Boulder Design Advisory Board Agenda

RE: 1750 14th St., The James, BDAB Re-Submittal

The James

Boulder Design Advisory Board Re-Submittal

View from 14th Street -Revised

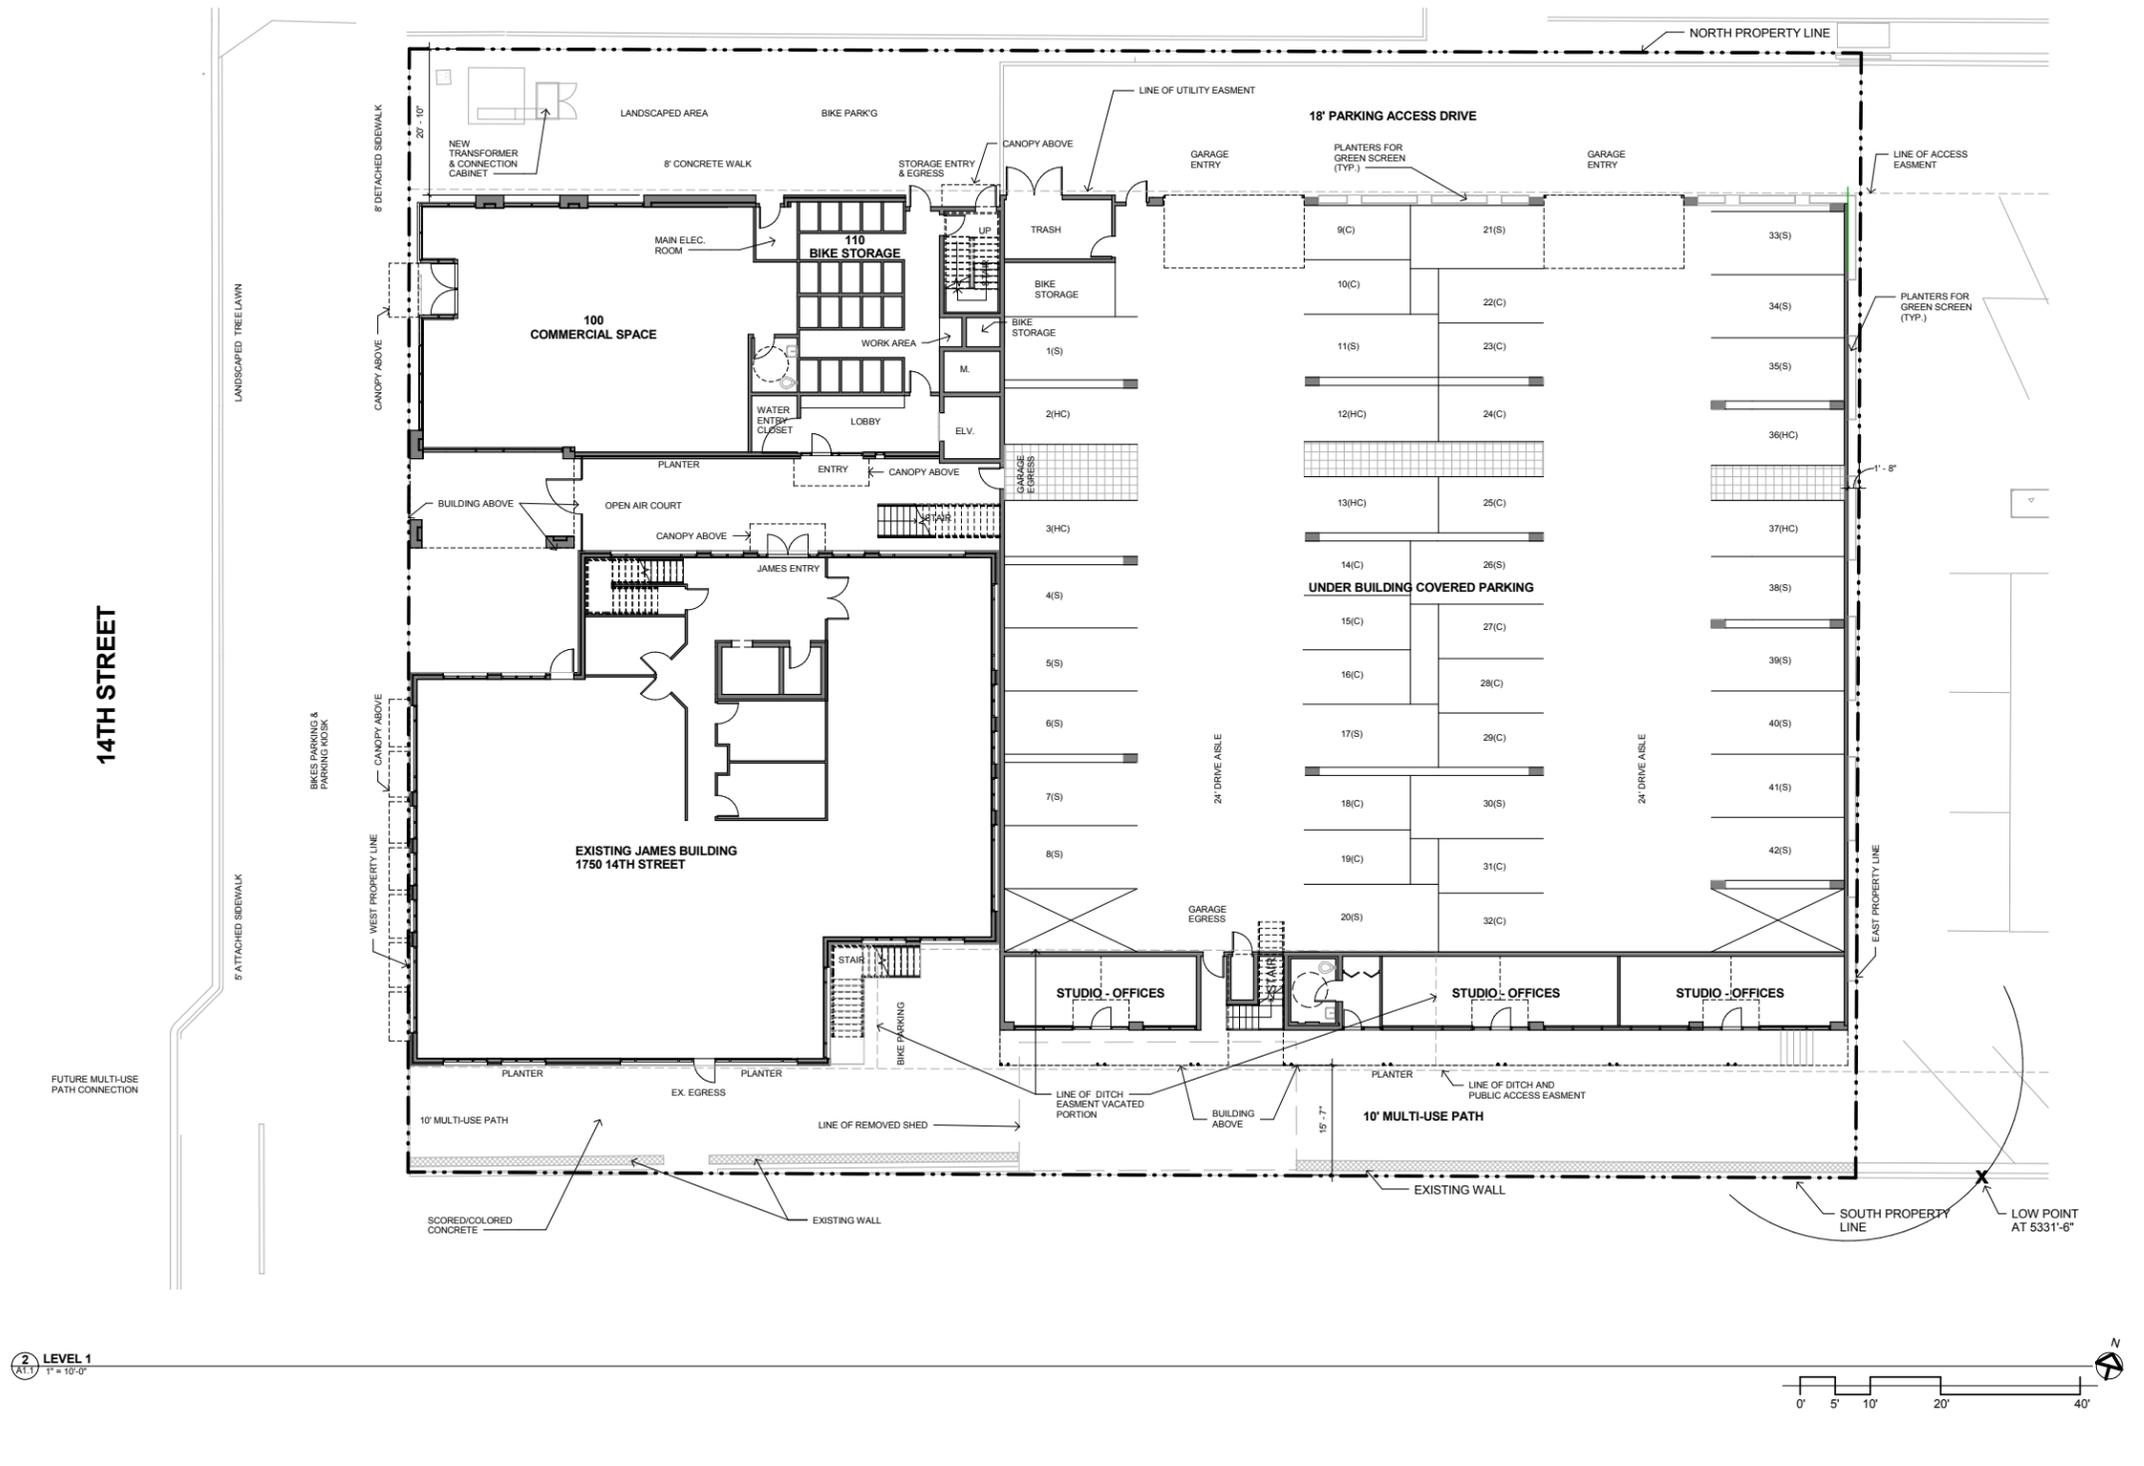
- 1) 2' sills were added on the second and third floor windows on the commercial building
- 2) The lower level head was raised by 1' making the base appear taller. We looked at raising the second floor but given the need to align with the amenity deck with the existing James, this proved impossible. Ironically, the two guidelines of aligning floors with adjacent buildings and providing a 14' first floor are in conflict in this case, and the alignment was deemed to be more appropriate.

- 3) A larger awning was created at the transom level. This transom is extended to the portal to the arcade with signage placed between it and the masonry head in both locations.

- 4) The brick parapet wall was raised by 1' at the fourth floor to create a smaller metal railing zone and a stronger masonry edge
- 5) The columns at the first floor were re-configured to strengthen the differentiation of the first floor.

- 6) A plate steel kick plate was added to the storefront.
- 7) The entry doors were recessed to the main commercial space
- 8) Steel channel columns were integrated into the storefront to create a lighter secondary system.

- 9) The roof above the commercial building was rotated so that the front wall is lower by about 3'. More glass was added to the top floor and the windows were re-configured to better integrate with the lower levels and roof.
